Subject: ~~SAS-2.1~~ SPL: 08-249 Link Layer Power Management

Overview

This proposal is a complement to 08-015 and 08-206. This proposal focusses on link layer changes to support lower power modes.

Figure 118 — SL (link layer for SAS logical phys) state machines (part 1)

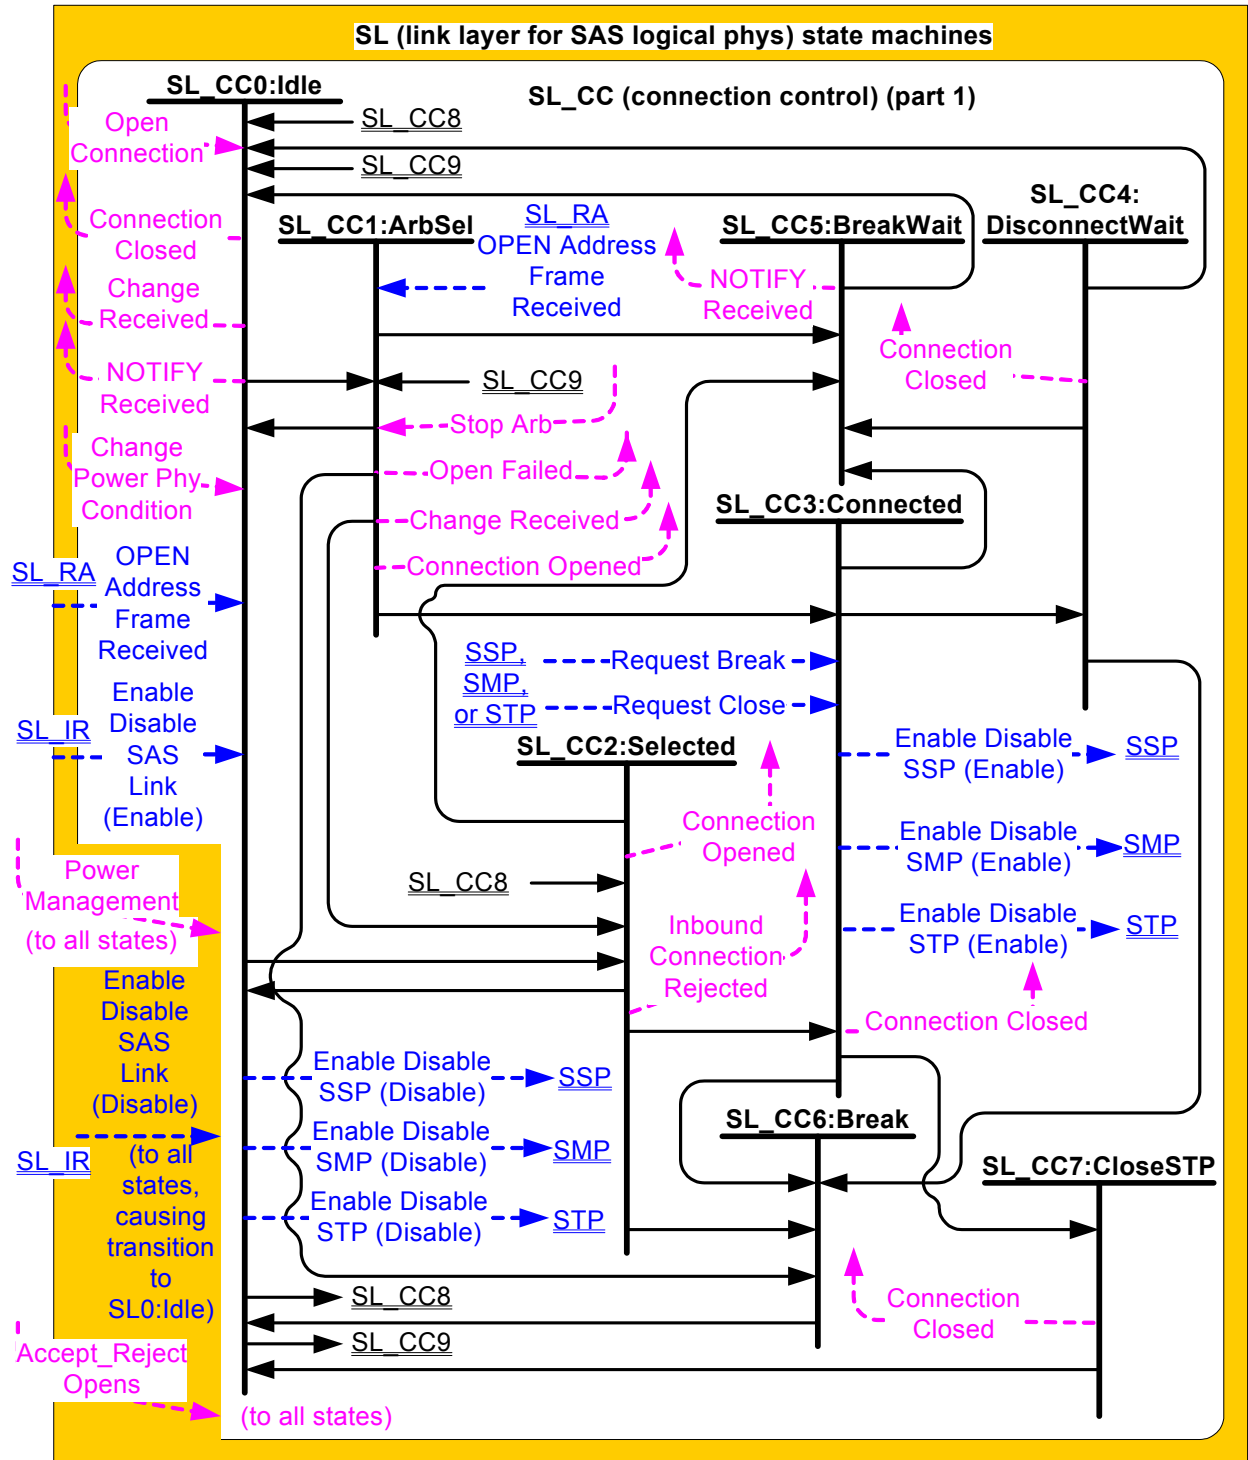
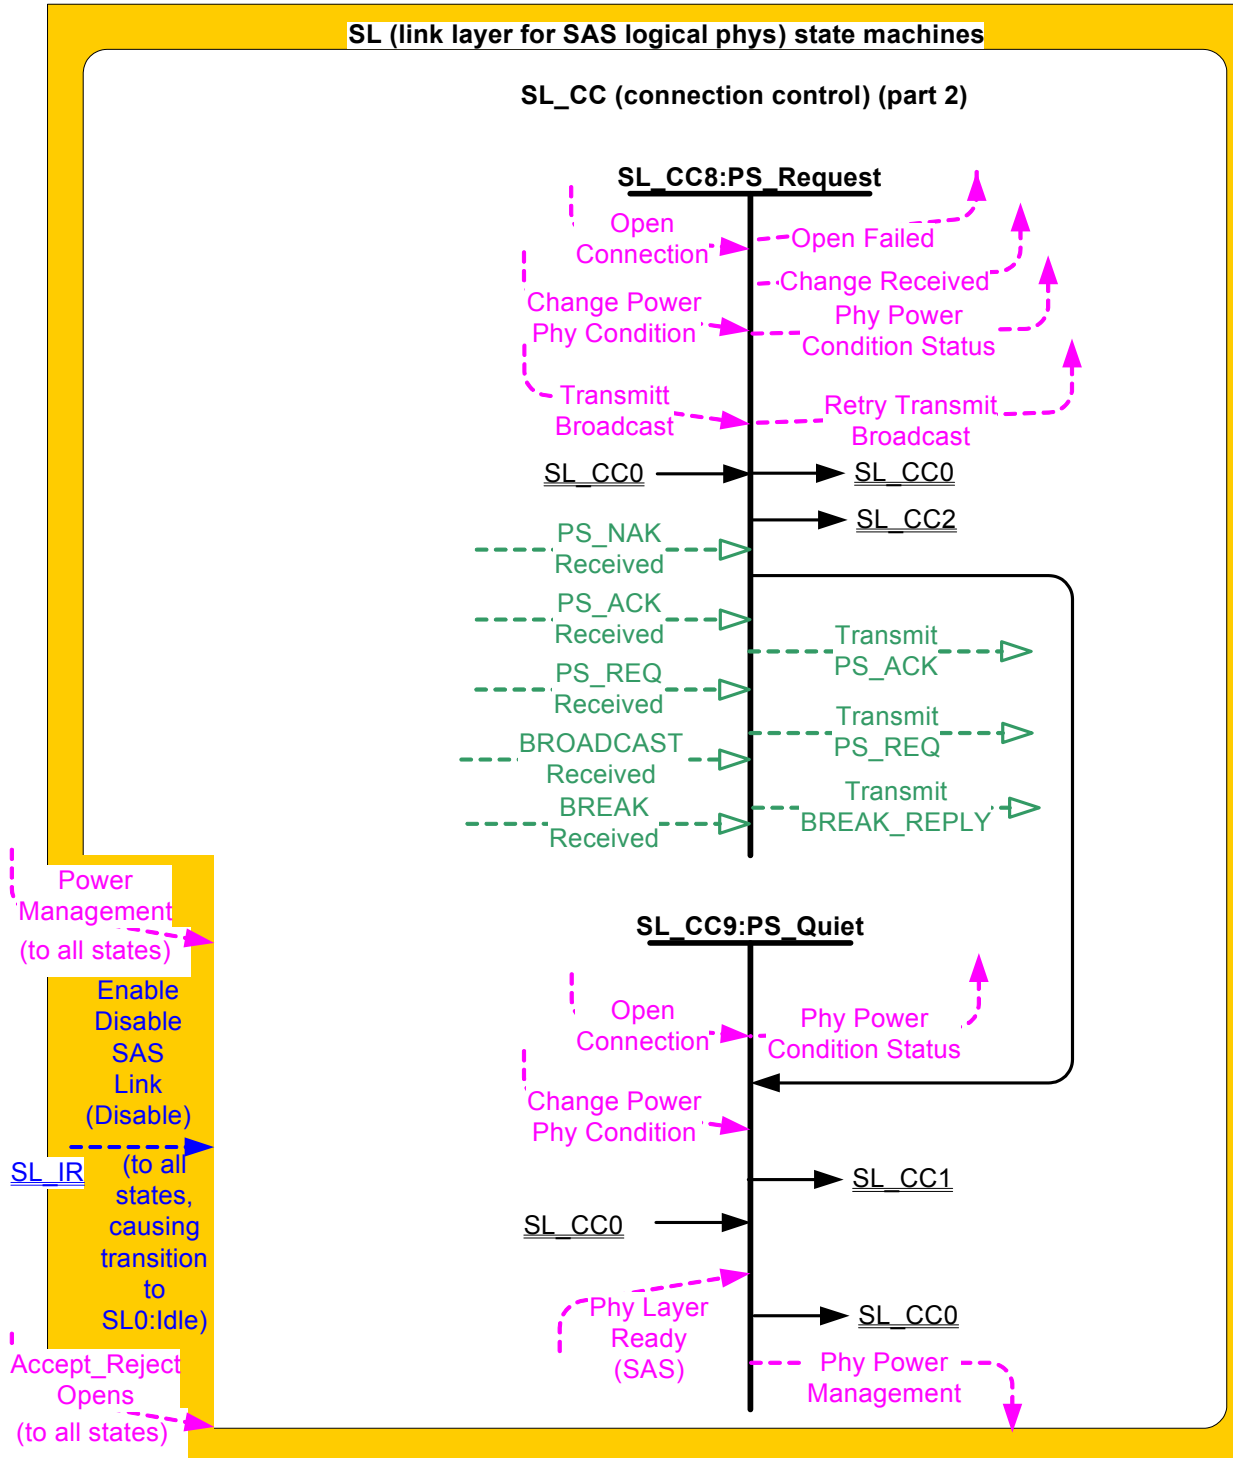
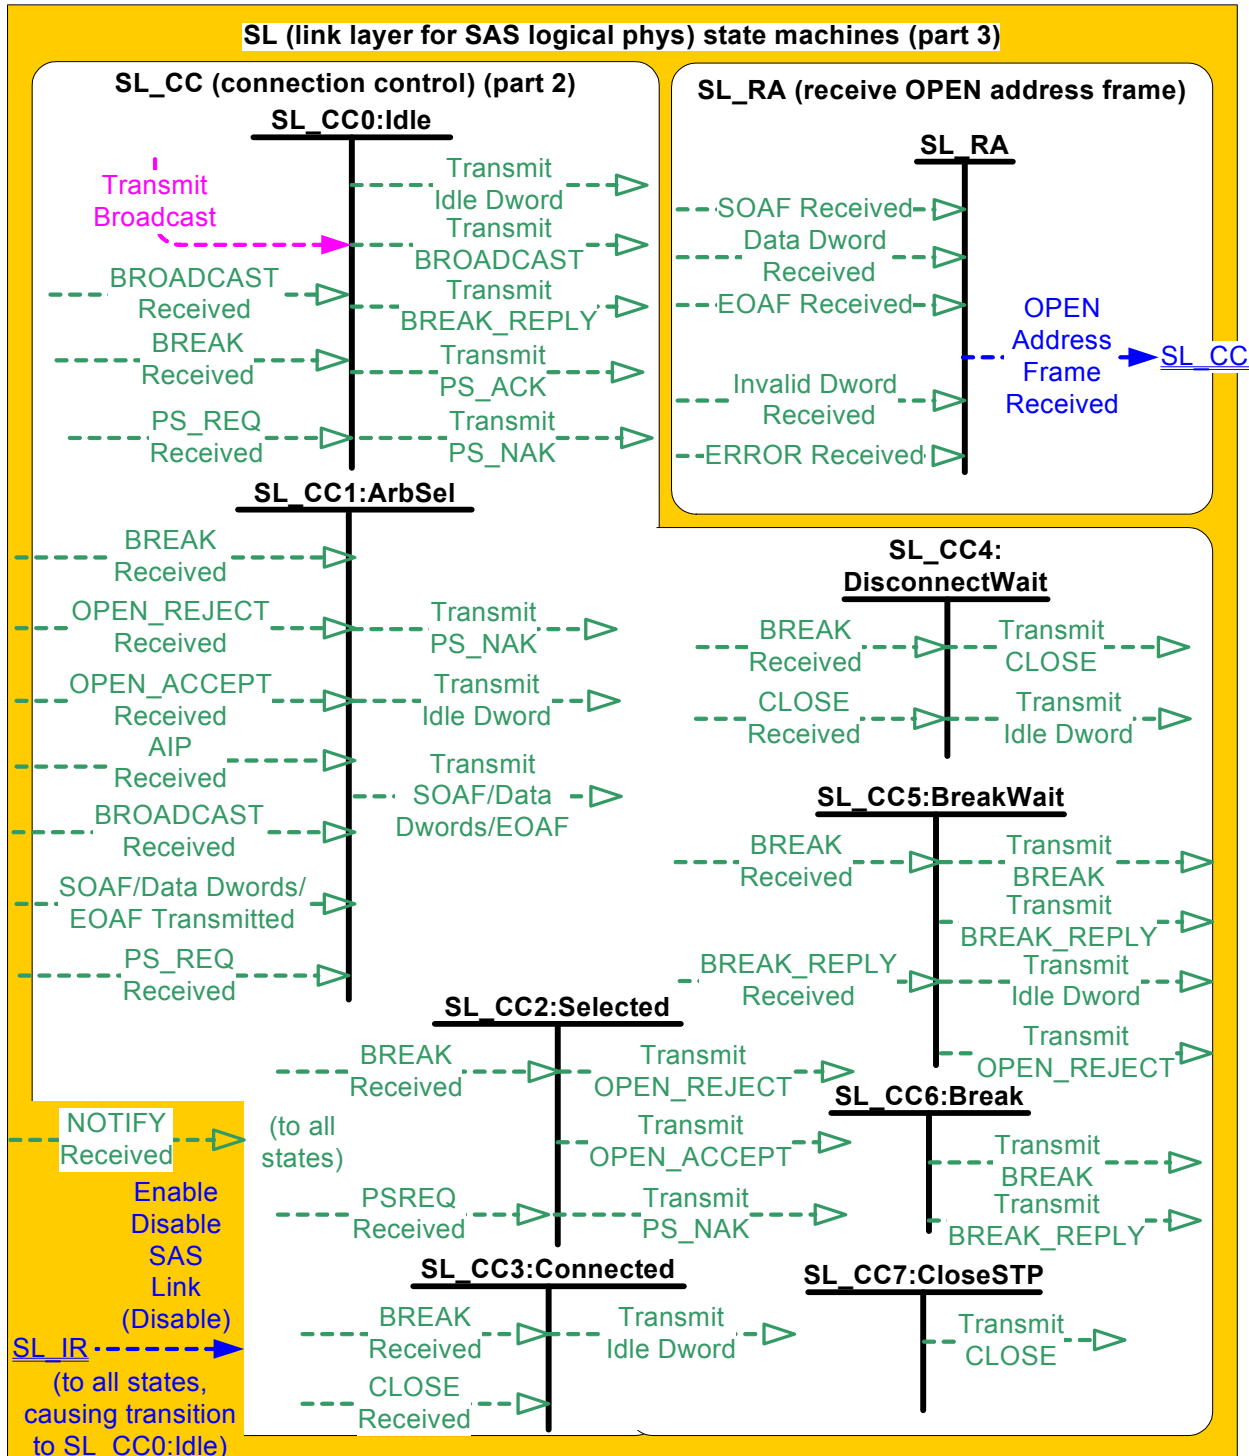
Editor's Note 0: Need to update figures with new states, and with Request Power Management request coming down, and Phy Power confirmation coming up.

Figure 121 — XL (link layer for expander logical phys) state machine (part 1)

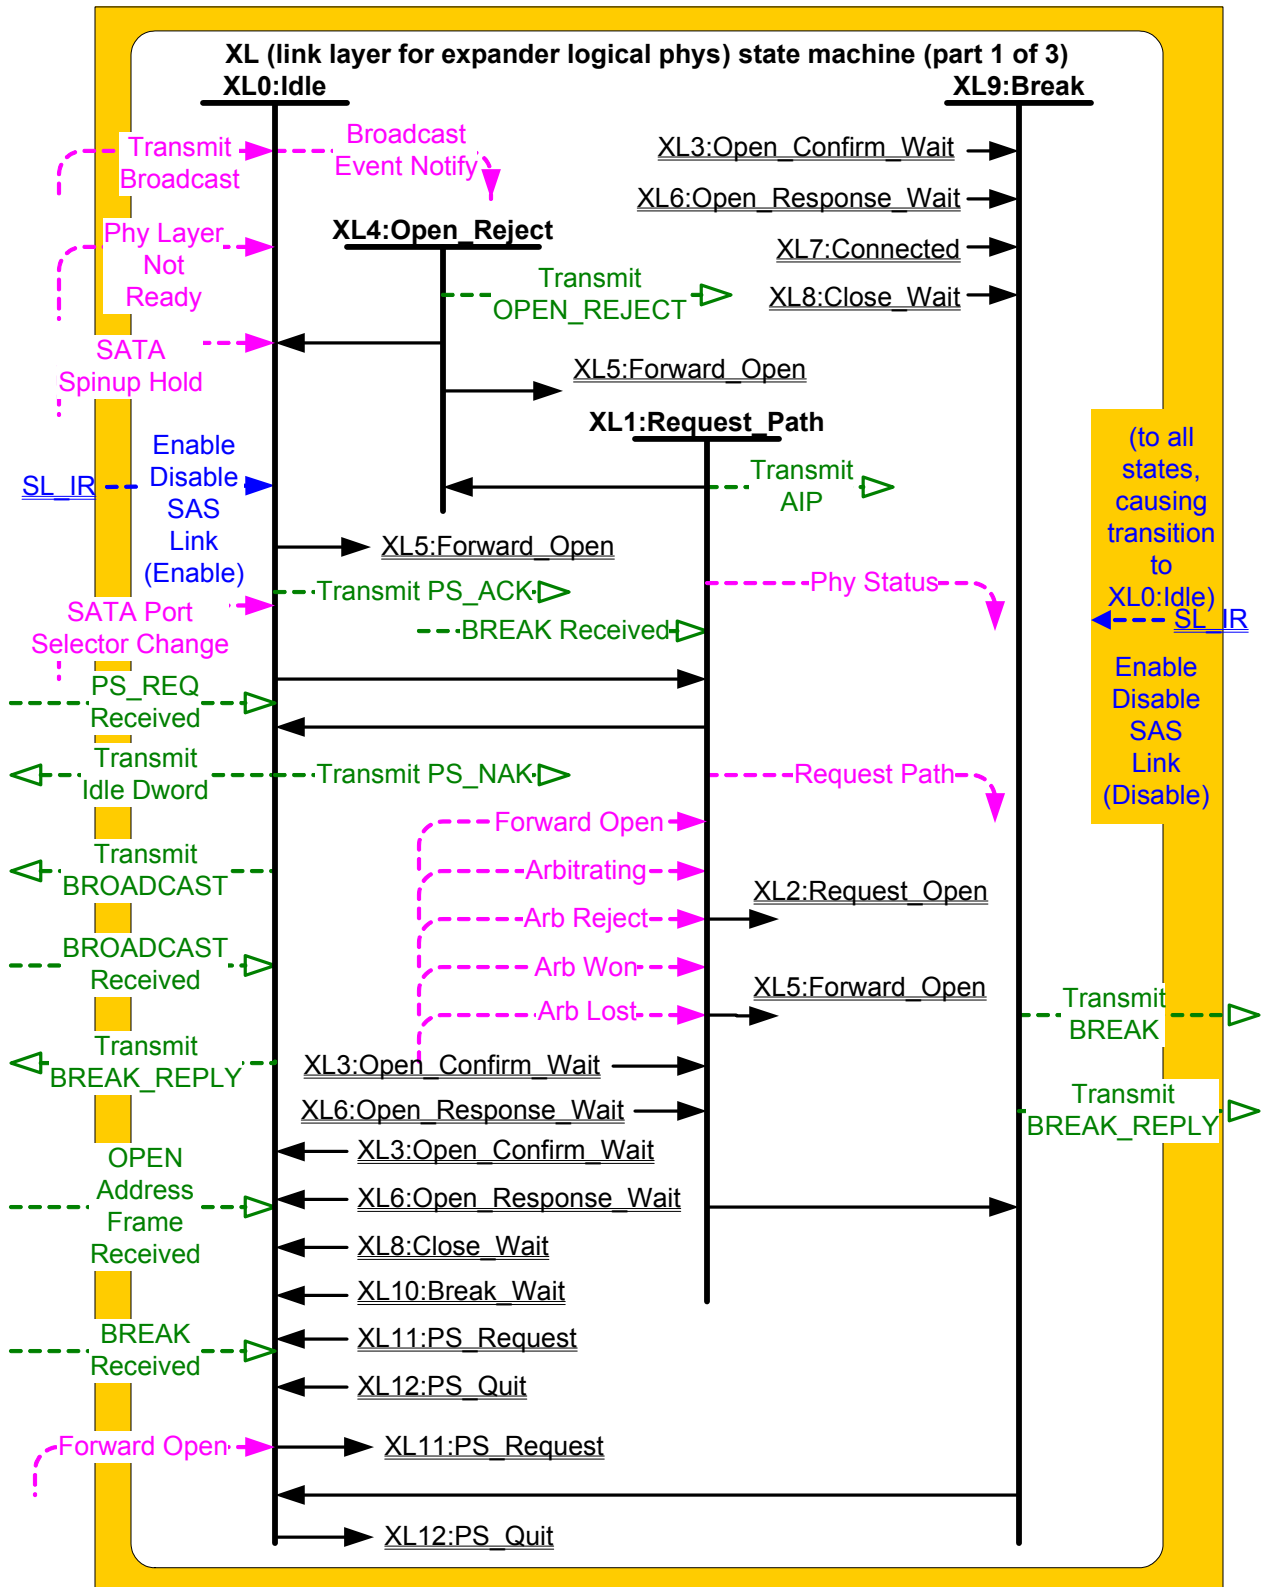
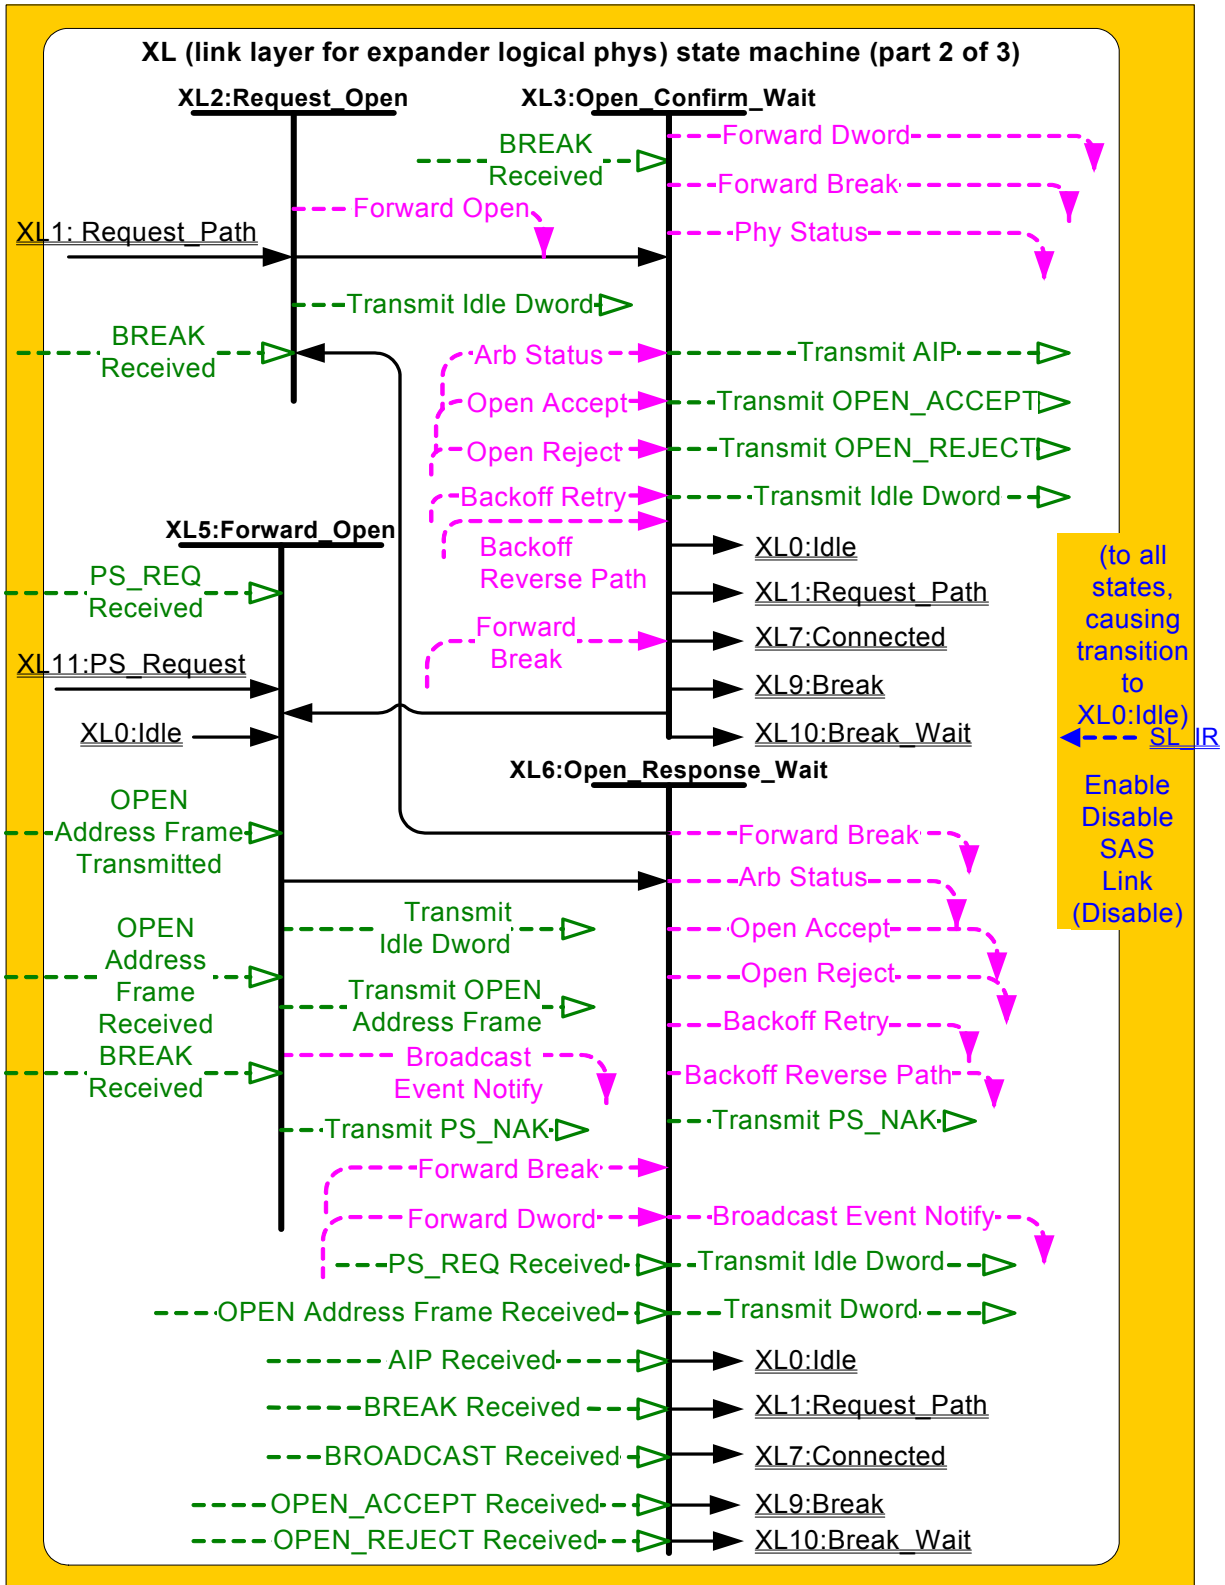
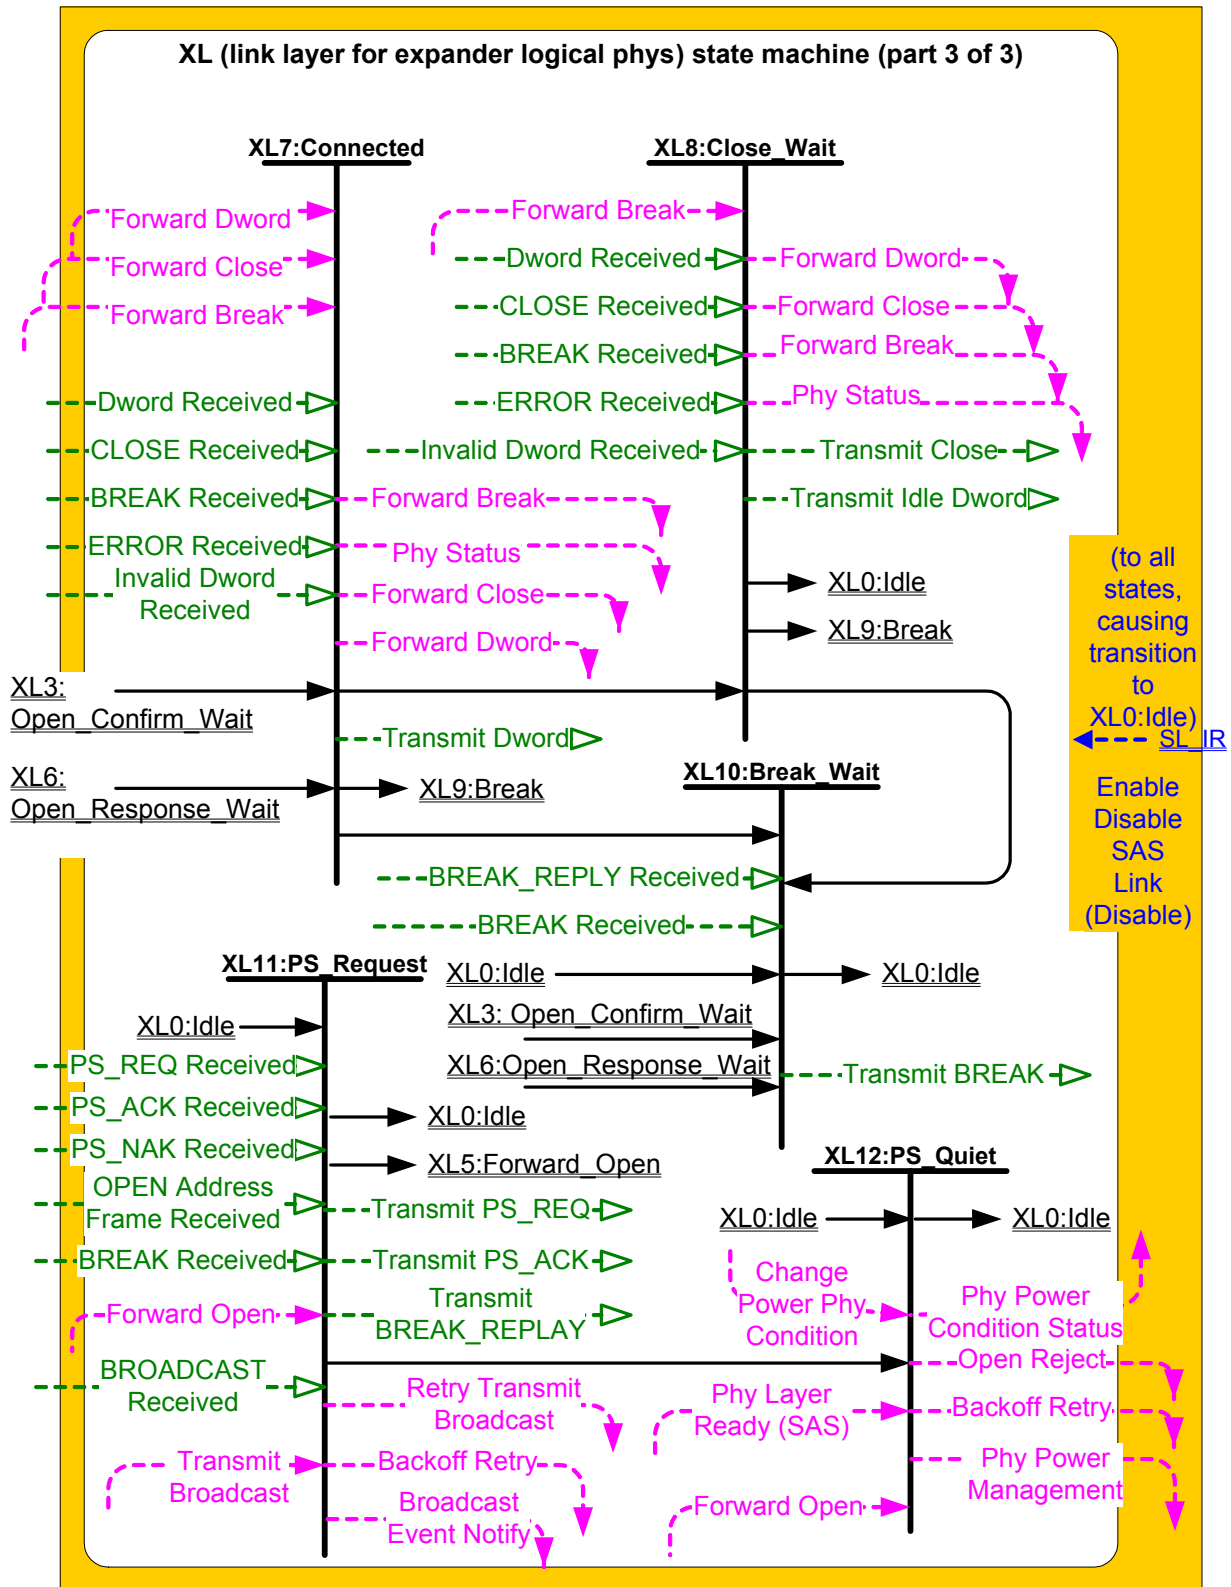
Editor's Note 11: Need to update figures with new states, and with Request Power Management request coming down, and Phy Power confirmation coming up.
